Project: Presidio-Lely International Airport (PRS)
Construct PAPI-4s
AIP No.: 3-49-0024-066-2025

ADDENDUM NO. 1

PRESIDIO LELY INTERNATIONAL AIRPORT
RUNWAY 17-35 INSTALLATION OF PAPI-4S

5 ACCESS ROAD ELECTRICAL DUCTBANK TRENCH REPAIR DETAIL
NOT TO SCALE

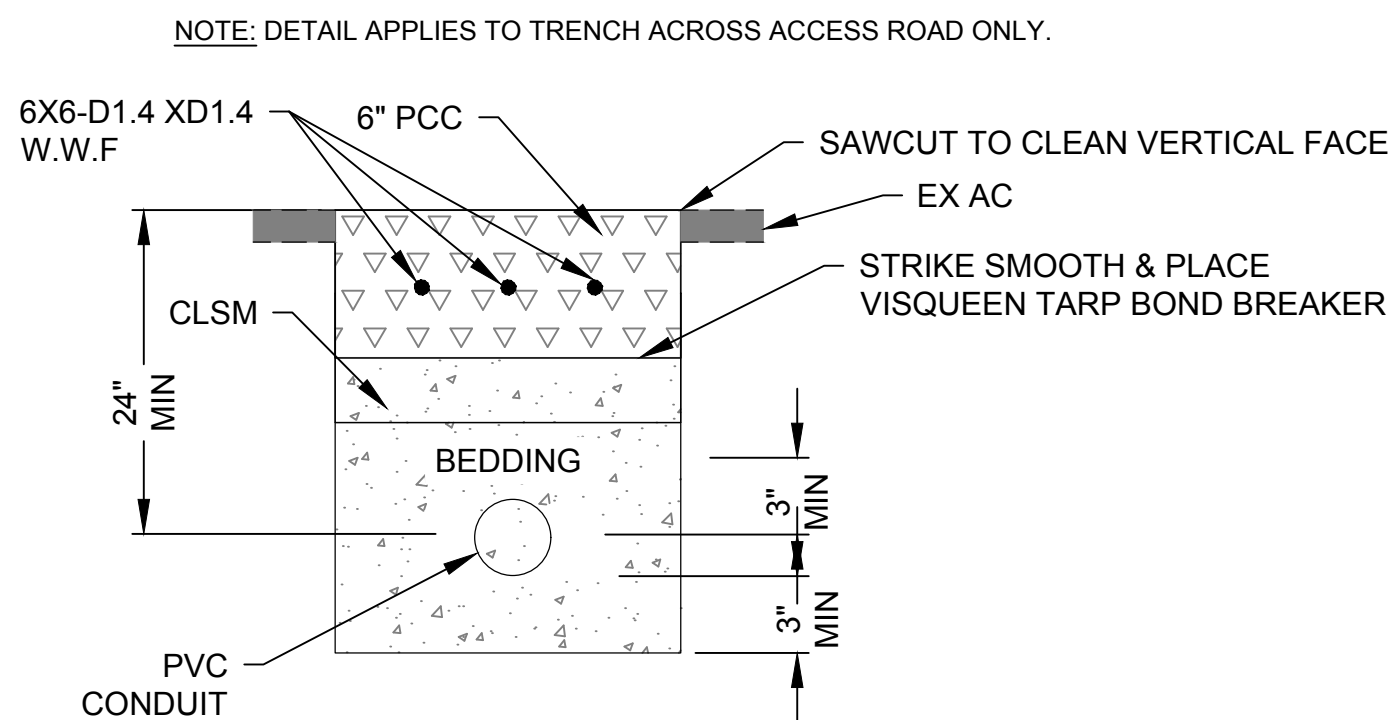
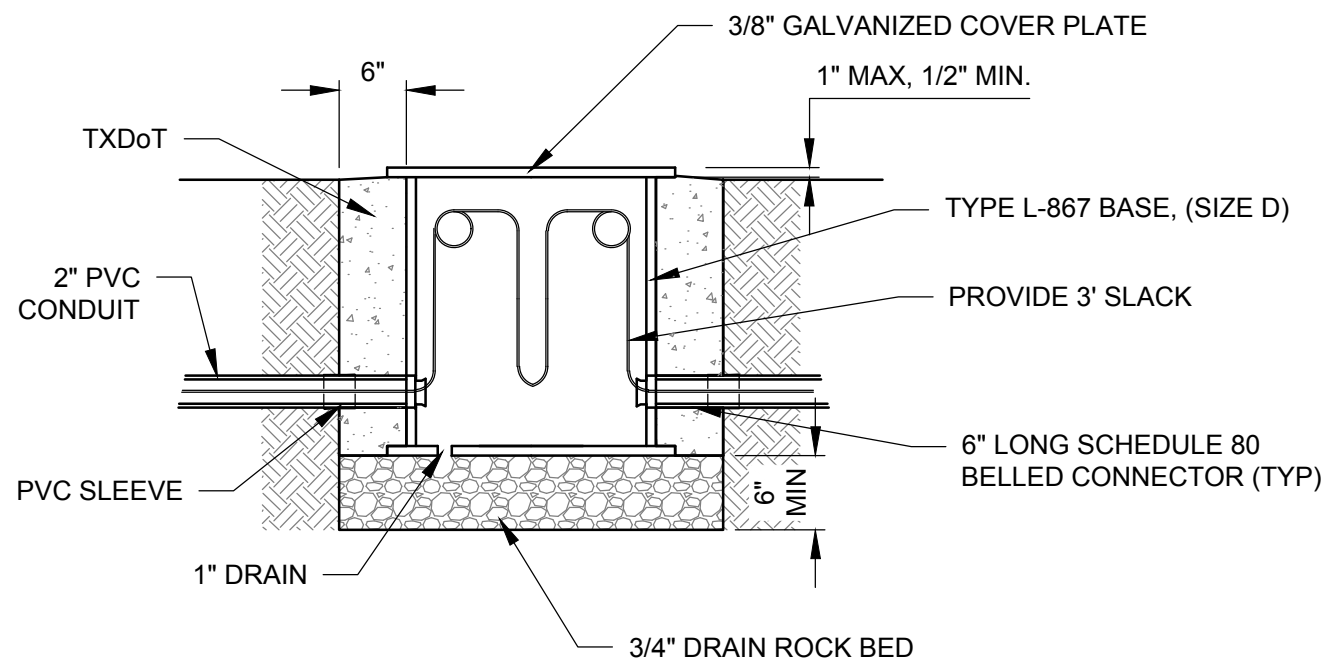
- Q5. On sheet E-601 Detail #5 Access Road Electrical Duct Bank Trench Repair Detail, may the detail be altered to use the CLSM in place of the base course and cap it with 6" of reinforced 3500 PSI concrete?
A5. See Attachment 1 for acceptable alternate road patch design.

- R1. Modified Sheet E-601, Detail #5, Access Road Electrical Ductbank Trench Repair Detail
- R2. Modified Sheet E-701, Detail #2, Plan Unit Plan View (TYP) Detail.
- R3. Modified Sheet E-701, Detail #2, PAPI Lighting Unit (TYP) Detail: Alternate Foundation.
- R4. Revised specification L-125 to include flight check attendance with a bid item L-125-5.4.
- R5. Revised Bid Form to include flight check attendance under item L-125-5.4.

5 ACCESS ROAD ELECTRICAL DUCTBANK ALTERNATE TRENCH REPAIR DETAIL
NOT TO SCALE

NOTE: DETAIL APPLIES TO TRENCH ACROSS ACCESS ROAD ONLY.
